**FINDINGS AND RECOMMENDATION  
OFFICE OF PLANNING AND ZONING  
ANNE ARUNDEL COUNTY, MARYLAND**

**CASE NUMBER:** 2023-0109-V

**REQUEST**

The applicants are requesting a variance to allow a dwelling with less setbacks than required on property located at 1420 Woodland Beach Road in Pasadena.

**ADMINISTRATIVE SITE PLAN**  
**DUFFY/CUSHING PROPERTY**  
**PARCEL 246**  
**1420 WOODLAND BEACH RD. PASADENA, MD. 21122**  
TAX MAP 17 BLOCK 6 PARCEL 246 TAX ACCOUNT #: 3000-0701-6100 ZONING: R2  
DATE: MARCH 12, 2023  
THIRD ASSESSMENT DISTRICT ANNE ARUNDEL COUNTY, MARYLAND  
**SHEET 1 of 1**

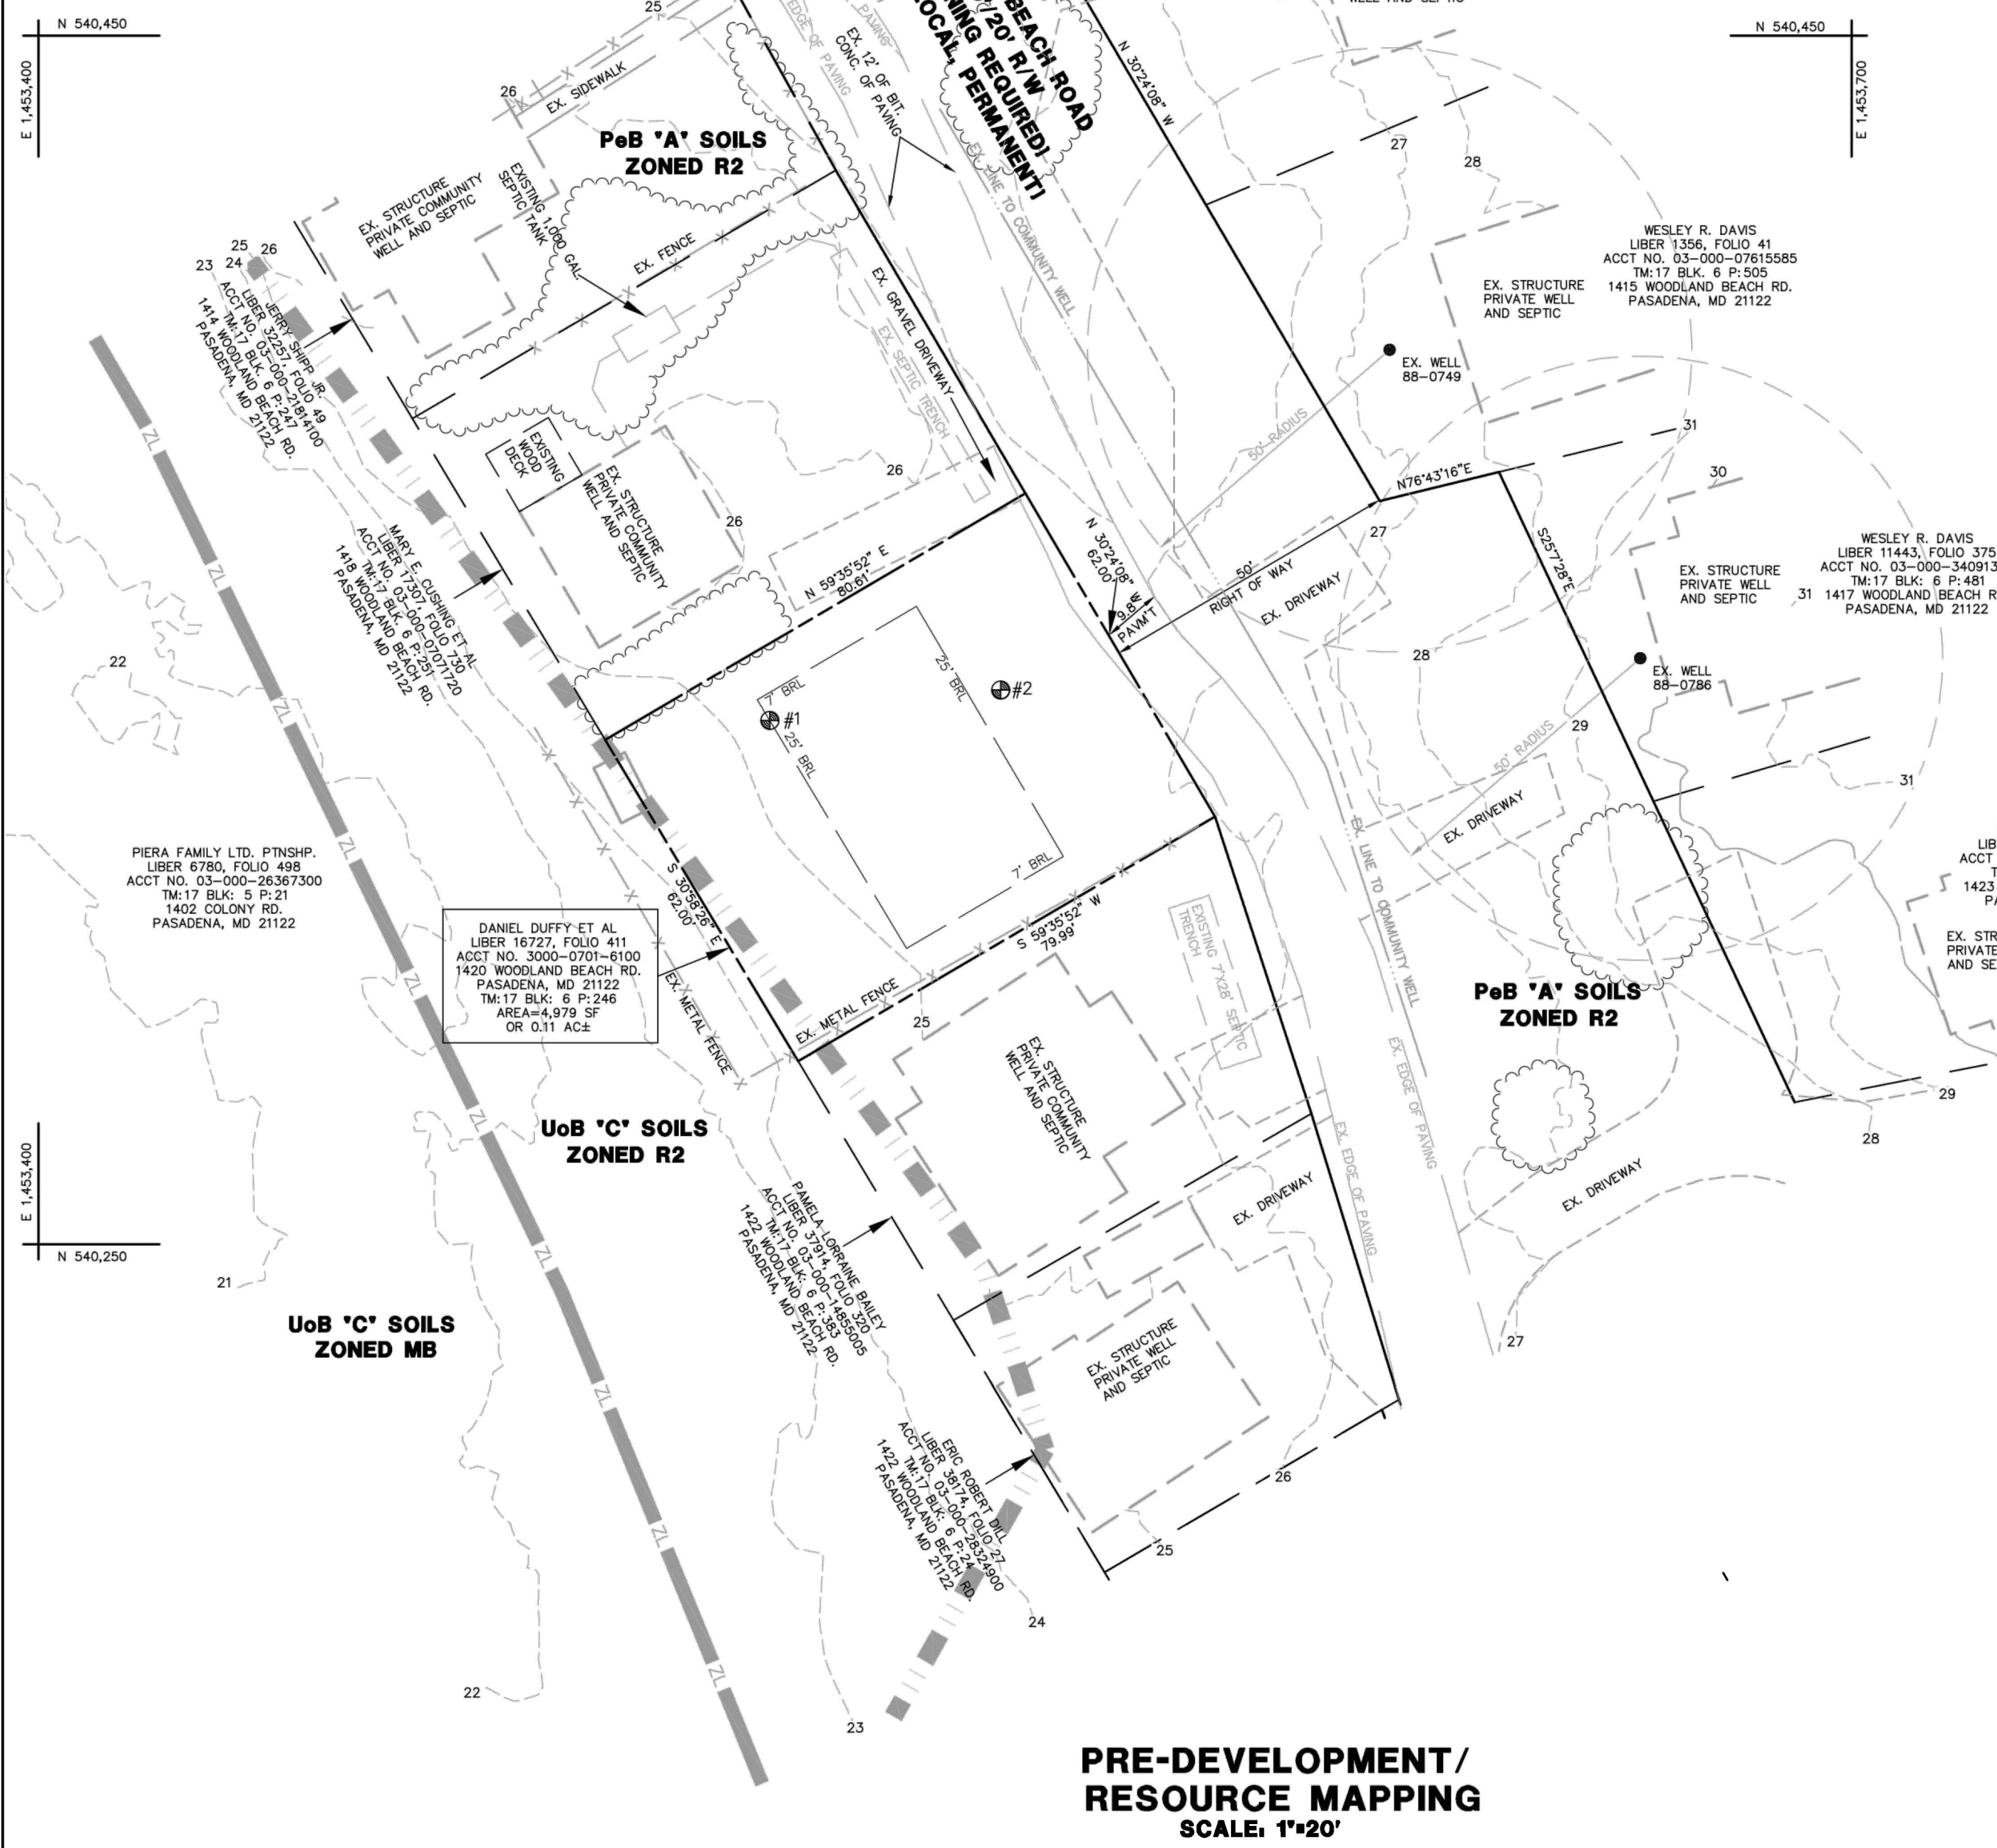
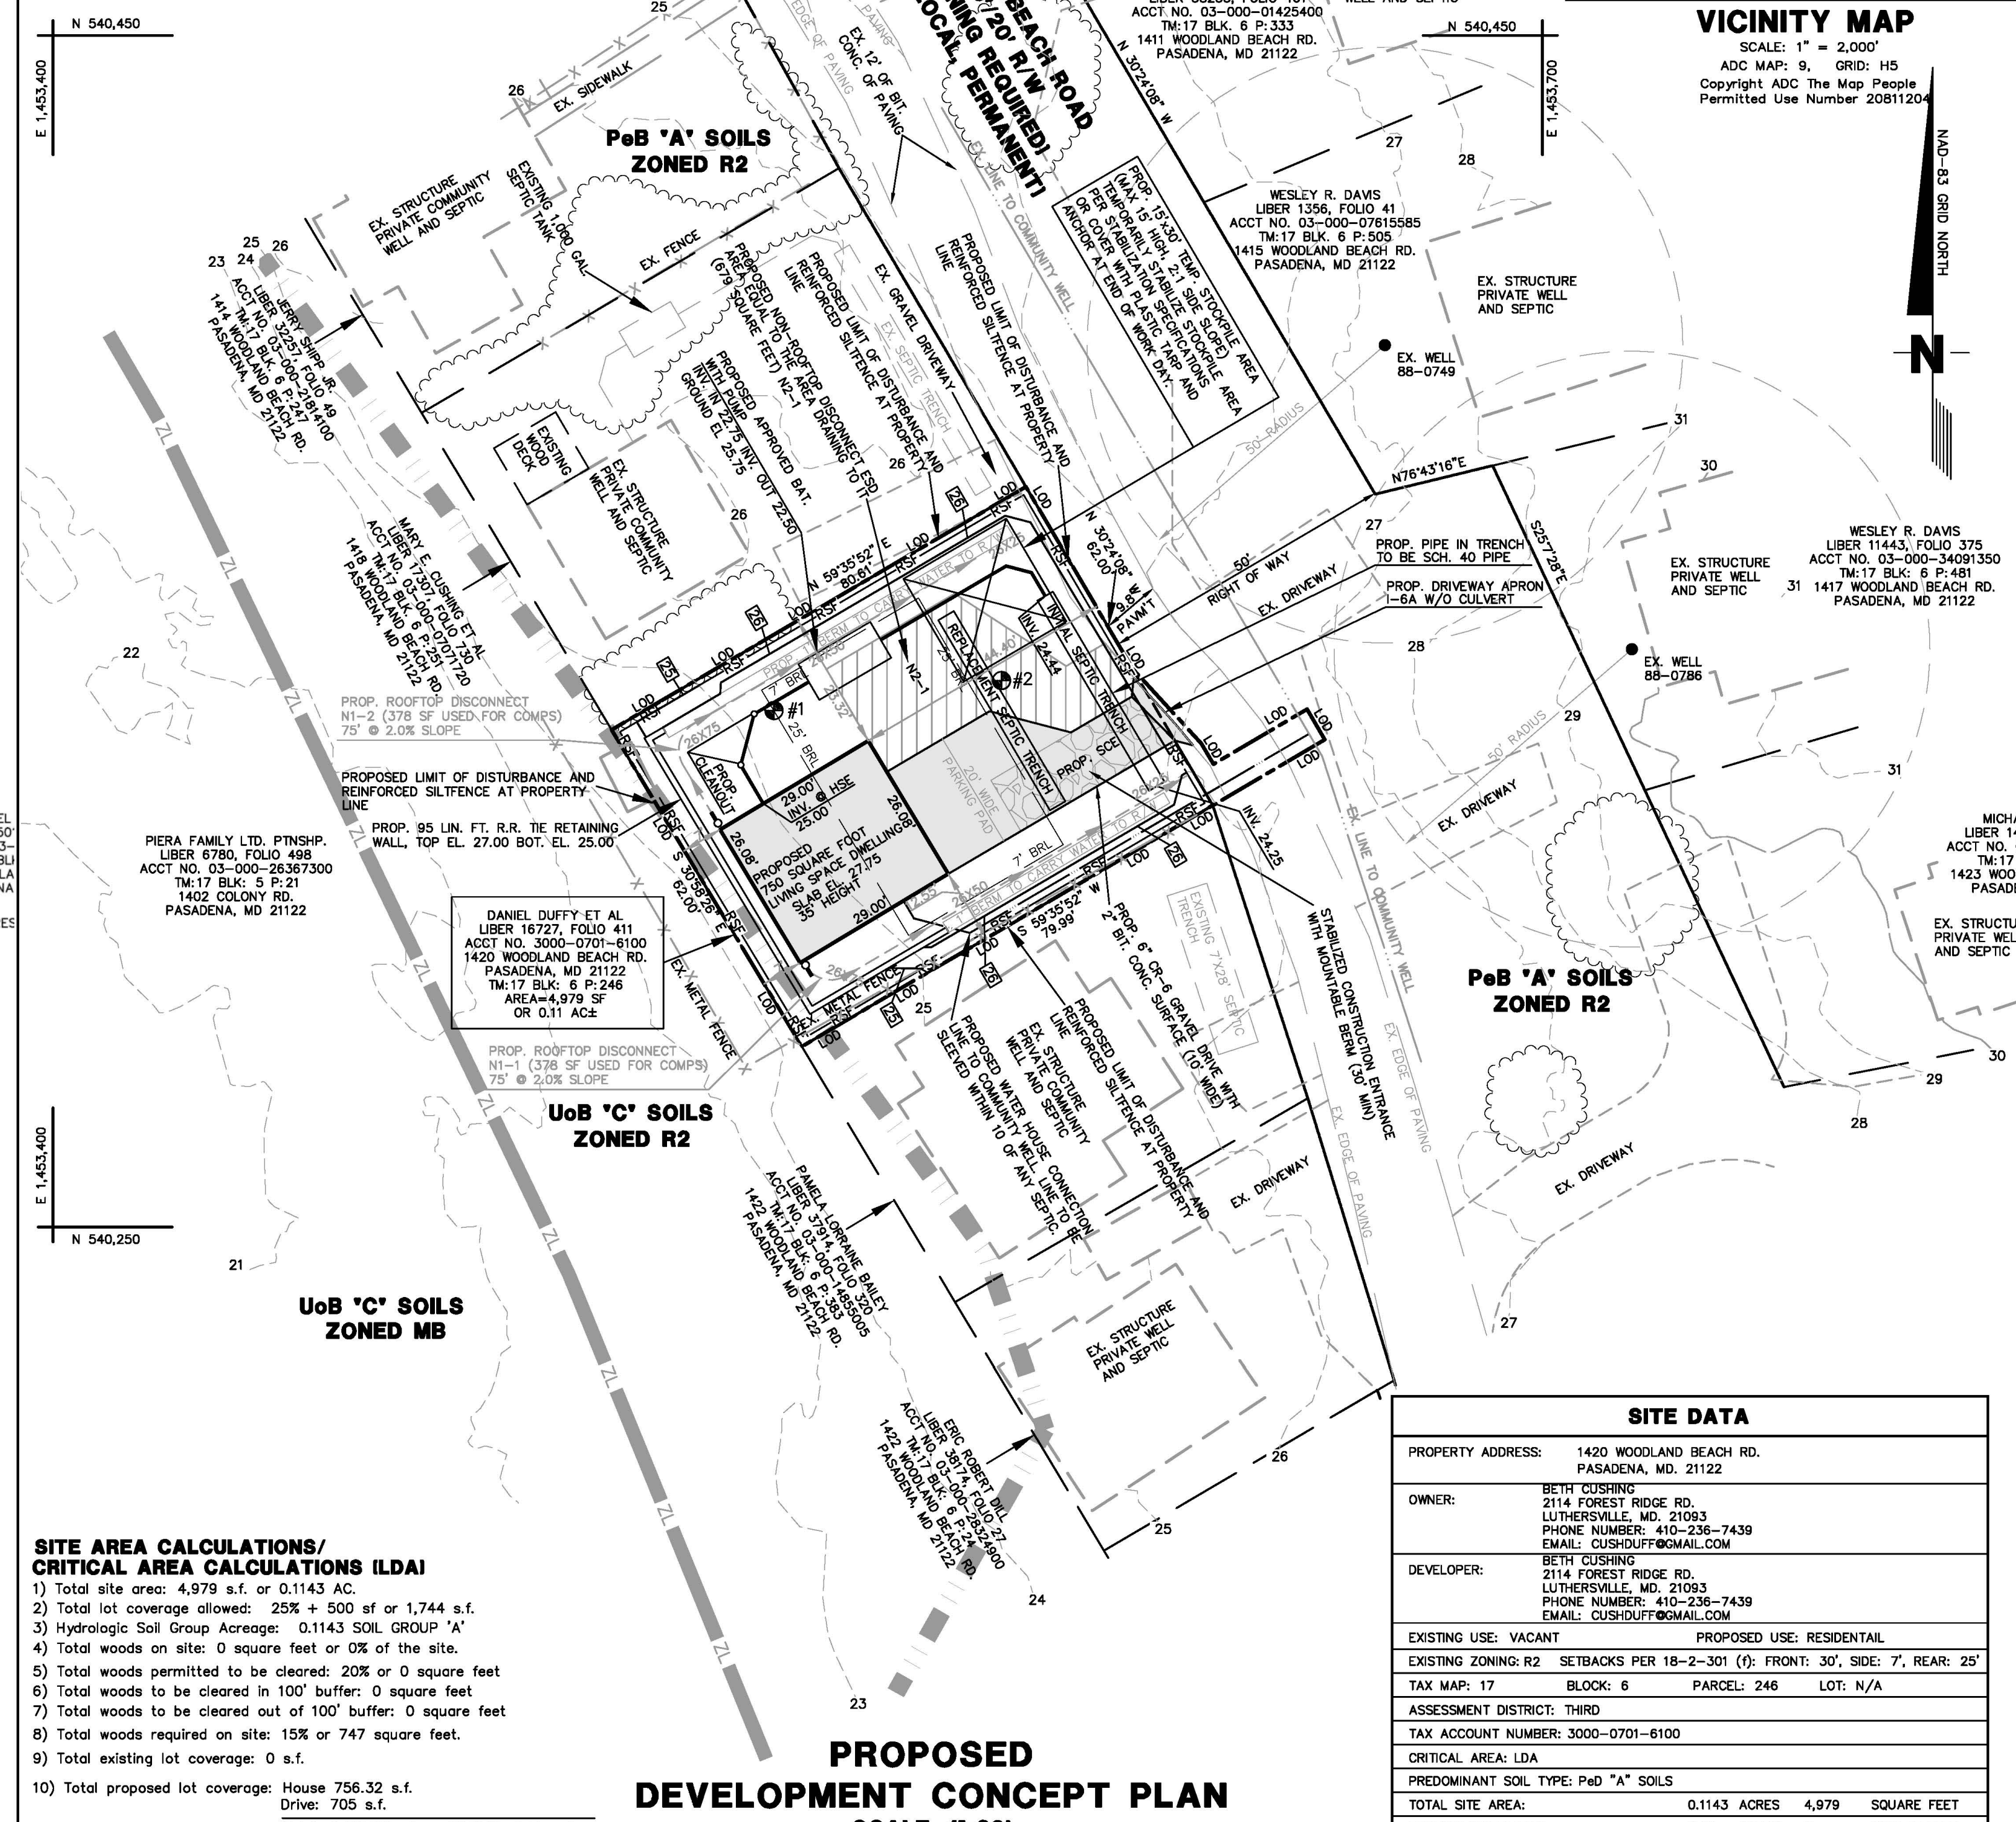
The **Engineering Section** has noted that the design, as proposed, does not provide sufficient space to adequately address the SWM regulations to provide ESD to the MEP. The construction of the retaining wall and the diversion of the roof drainage around the house to the public road right of way (which lacks a public storm drain system) do not address SWM requirements and alter the drainage pattern in a manner that may exacerbate existing road flooding. Downstream road cross-sections were not provided to ensure an open drainage path exists to receive the proposed concentrated flows. No downstream investigation was conducted to show the impact of this construction on road flooding. In addition, their Office states that the applicants did not address the pre-file comments regarding the lack of SWM treatment. Their Office does not support this variance request and recommends denial since the development, as proposed, does not meet the regulatory SWM treatment requirements.

The design, as proposed, does not provide sufficient space to adequately address the SWM regulations to provide ESD to the MEP. The construction of the retaining wall and the diversion of the roof drainage around the house to the public road right of way (which lacks a public storm drain system) do not address SWM requirements and alter the drainage pattern in a manner that may exacerbate existing road flooding. Downstream road cross-sections were not provided to ensure an open drainage path exists to receive the proposed concentrated flows. No downstream investigation was conducted to show the impact of this construction on road flooding.

The applicant did not address the pre-file comments regarding the lack of SWM treatment.

The applicant is proposing to construct a new single-family detached dwelling with a total proposed impervious of 1,517 square feet. The total disturbed area is shown as 5,152 square feet. The applicant is proposing to disconnect the non-rooftop surface (driveway) via an area next to the driveway that is equal to the area of the driveway. This area must be shown to be down gradient of the impervious cover and must be vegetated. Soil borings and photographs are required to document the status of this area and the need of soil amendments. A 1-2 feet wide transition strip should be provided from the disconnected area to the vegetated area. The plan also needs to show that the disconnection is at least 10 ft from the nearest impervious surface of similar or lower elevation to prevent reconnection. This was not demonstrated.

The proposed rooftop disconnect as proposed does not meet the intent of the MDE criteria for non-rooftop disconnect credit and is not acceptable as shown. The downspouts should be disconnected via sheet flow, where no more than 500 SF of impervious is allowed to sheet flow over a vegetated area that is at least 75 feet of length. Installing a retaining wall and berms as shown for the sole purpose to carry the water to the public road right of way is not considered "nonstructural" and creates a concentrated flow. This design does not meet the non-rooftop disconnection criteria intent or purpose.

No public storm conveyance system appears to be in the public right of way to intercept and convey the flow. A downstream investigation of the drainage patterns along with cross-sections to demonstrate the outfall is adequate and to show the existing and proposed flooding limits for the 10 year storm and their encroachment levels to private properties will need to be submitted. A more detailed certified survey with spot elevations along with cross-sections will be required and a right to discharge permit maybe required to address any drainage to private properties.

Based upon the standards set forth in § 18-16-305 of the County Code under which a variance may be granted, this Office recommends ***denial*** of a zoning variance to § 18-4-601 to allow a dwelling as close as 7 feet to the rear lot line, as proposed.

**Determination** –This office does not support this variance request and recommends denial since the proposed development as proposed does not meet the regulatory SWM treatment requirements.
